TRANSMITTAL MEMO

Re: Opinion pursuant to WAC 173-340-515(5) on Proposed Remedial Action for the following Hazardous Waste Site:

• Name: Eddon Boat Park

(Response to Technical Memorandum No. 3)

Figure 1, Proposed Investigation Activities.

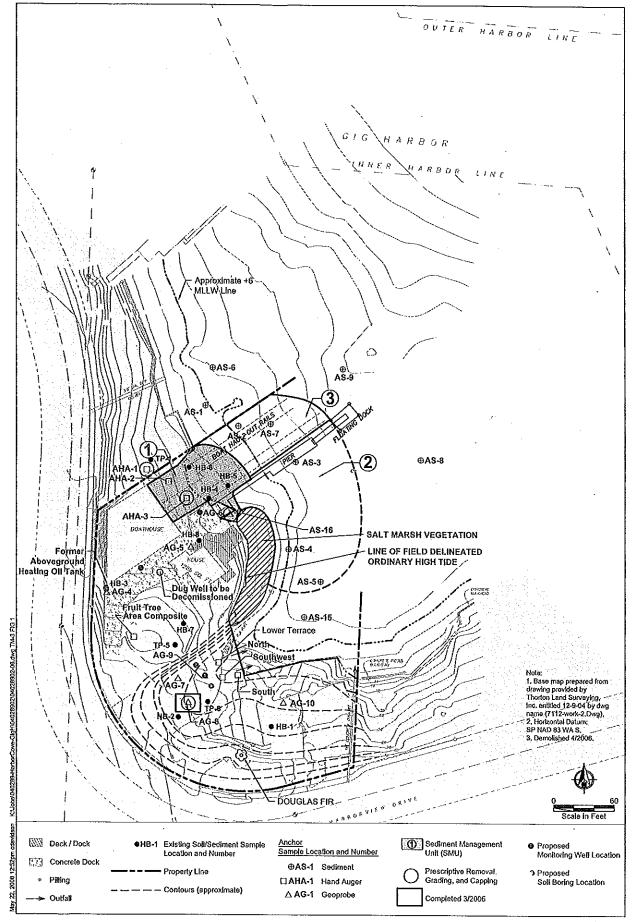
- 1. All groundwater analyses for polynuclear (polycyclic) aromatic hydrocarbons (PAHs) should include the full 8270 (semi-volatile organic compound) list as well as a separate low-level analysis for carcinogenic PAHs (cPAHs) using 8270-Specific Ion Methodology (SIM).

- 2. AG-9 Area. Carcinogenic PAHs were previously detected at location AG-9 at a depth of 8- to- 10-feet below ground surface (bgs). The work plan states that a soil sample will be collected from the groundwater monitoring well at this location at a depth of 8- to- 10-feet bgs. Due to grading at the site, ground surface elevations may have changed. Please verify the ground surface elevation of the proposed monitoring well near AG-9 and modify sampling depths accordingly. Also, if contamination is detected in the equivalent 8- to- 10-feet bgs sample, additional analyses will be necessary to determine the depth of contamination. Therefore, it is recommended that additional samples be collected at depths greater than 10-feet bgs (equivalent) and be held in archive. All soil samples from the AG-9 Area analyzed for polynuclear (polycyclic) aromatic hydrocarbons (PAHs) should include the full 8270 (semi-volatile organic compound) list as well as a separate low-level analysis for carcinogenic PAHs using the 8270-Specific Ion Methodology (SIM).

- 3. <u>Above-ground Heating Oil Tank</u>. Samples for PAH analyses from the vicinity of the above-ground heating oil tank should consist of a low-level analysis for carcinogenic PAHs using the 8270-Specific Ion Methodology (SIM).

- 4. <u>AHA-1 Area</u>. The number of confirmation samples collected should be as per the October 2005 Opinion Letter. All soil samples from the AHA-1 Area should be analyzed for the following analyses:

- a. Full 8270 (semi-volatile organic compound) list
 - b. Separate low-level analysis for carcinogenic PAHs using the 8270-Specific Ion Methodology (SIM).

- c. Petroleum hydrocarbons by the hydrocarbon identification method (HCID) with follow-up total petroleum hydrocarbon analyses if hydrocarbons are detected.
- d. Also, the excavation bottom sample for volatile organics compounds analysis should be collected and prepared using EPA Method 5035A.
